SOLICITATION AMENDMENT
MODIFICATION DE L'INVITATION

Title - Sujet FIT-UP CONSTRUCTION - BRIDGEWATER	
Solicitation No. - N° de l'invitation EB144-150311/A	Amendment No. - N° modif. 005
Client Reference No. - N° de référence du client EB144-15-0311	Date 2014-07-03
GETS Reference No. - N° de référence de SEAG PW-\$PWA-122-5085	
File No. - N° de dossier PWA-4-72004 (122)	CCC No./N° CCC - FMS No./N° VME
Solicitation Closes - L'invitation prend fin at - à 02:00 PM on - le 2014-07-10	Time Zone Fuseau horaire Atlantic Daylight Saving Time ADT
F.O.B. - F.A.B. Plant-Usine: <input type="checkbox"/> Destination: <input checked="" type="checkbox"/> Other-Autre: <input type="checkbox"/>	
Address Enquiries to: - Adresser toutes questions à: Chinye (PWA), Chukwudi	Buyer Id - Id de l'acheteur pwa122
Telephone No. - N° de téléphone (902) 496-5476 ()	FAX No. - N° de FAX (902) 496-5016
Destination - of Goods, Services, and Construction: Destination - des biens, services et construction:

Amendment 005 is raised to answer the following questions and incorporate the changes below:

Question 2: Location: Outside Room 107

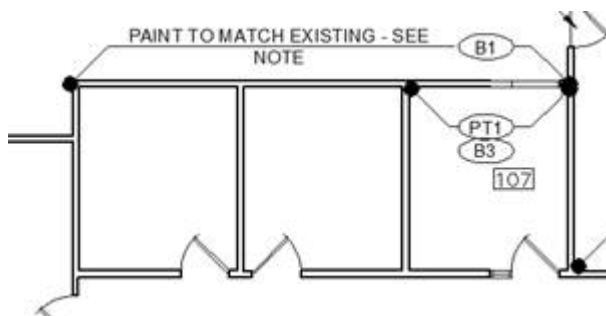
Existing textured paint is no longer available. Can an alternative be selected and will the entire wall be painted?

Answer to question 2: The entire wall to be painted as follows:

- Remove existing 4" section of chair rail and wall vinyl (below chair rail) located between the door frame and adjacent partition. Repair gypsum board and make ready to receive new paint finish.
- Prepare and make smooth existing partition, currently painted with spray applied textured paint, and make ready to receive new paint finish.
- Paint partition to match background colour of existing paint (cream).
